EXPOSITION LRT PROJECT PHASE 2
RFP No. XP8902-008
Venice Boulevard Underpass-Communication Lines Joint Trench
Coordination & Design (JTCD)

ADDENDUM

Addendum Number: 02

Addendum Date: July 22, 2011

DWPPS - CONCEPTUAL POLE LAYOUT

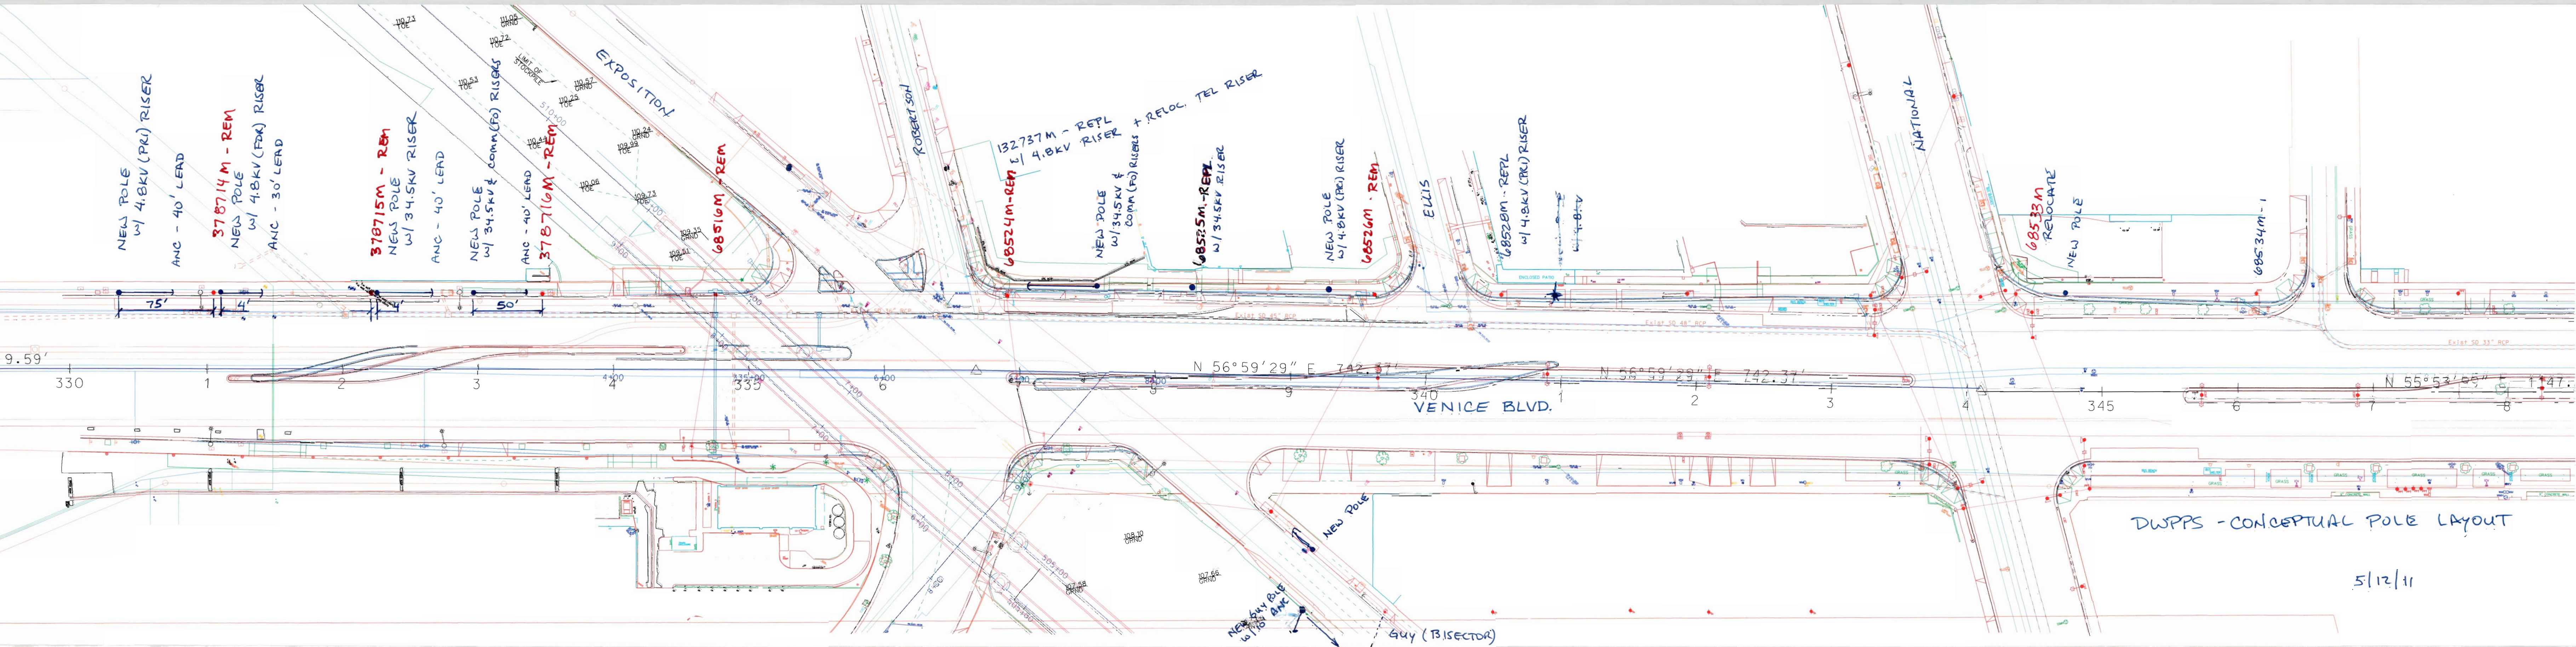
Add. Item No.	Document Title Description	Modifications
1.	Statement of Work Exhibit A Additional information	Venice Boulevard Underpass DWPPS Preliminary Pole Layout
